Access Compliance Report

Public Rights-of-Way

Intersection ID: 6454	Main Street: BRYAN_FURR_DR	Cross Street: SLATER_SPRINGS_DR	Location: SW
ADA ID: 655B62D9EA0C	Ramp Type: BlendTrans1	Initial Pass/Fail: Fail	Overall Compliance: No
		Severity Score: 25

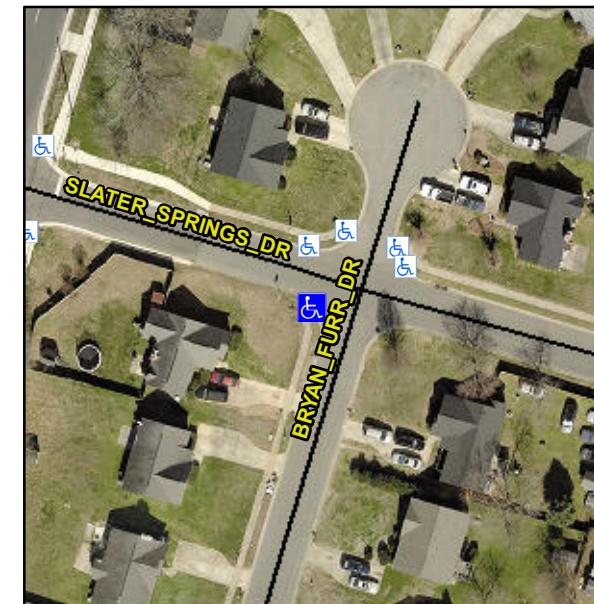
Not Found, R304.5.3

Compliance	Description	Data	Compliance	Description	Data
N/A	Ramp Length (in)	51.5	Yes	BlendTrans Slope (%)	1.8
Yes	Ramp Width (in)	48.5	No	BlendTrans XSlope (%)	7.5
N/A	Flare Type LT	N/A	N/A	Flare Type RT	N/A
N/A	Flare Slope LT (%)	N/A	N/A	Flare Slope RT (%)	N/A
N/A	Flare Traversable LT?	N/A	N/A	Flare Traversable RT?	N/A
N/A	Landing Length (in)	N/A	N/A	DWS Provided?	N/A
N/A	Landing Width (in)	N/A	N/A	DWS Contrast?	N/A
N/A	Landing Slope (%)	N/A	N/A	DWS Length (in)	N/A
N/A	Landing X Slope (%)	N/A	N/A	DWS Full Width?	N/A
N/A	Landing Curb? (Y/N)	N/A	N/A	DWS Offset (in)	N/A
N/A	Shared Landing?	N/A			
N/A	Gutter Ponding?	N/A	N/A	Gutter Slope (%)	N/A
N/A	Gutter Lip Ht (in)	N/A	N/A	Gutter X Slope (%)	N/A
N/A	Painted X Walk1?	No	N/A	Painted X Walk2?	N/A
	X Walk 1 Direction	To NW		X Walk 2 Direction	N/A
	X Walk 1 Width (in)	N/A		X Walk 2 Width (in)	N/A
	X Walk 1 Slope (%)	3.8		X Walk 2 Slope (%)	N/A
	X Walk 1 X Slope (%)	4.1		X Walk 2 X Slope (%)	N/A

Remove & Replace Curb Ramp With Two New Directional Ramps or Equivalent.
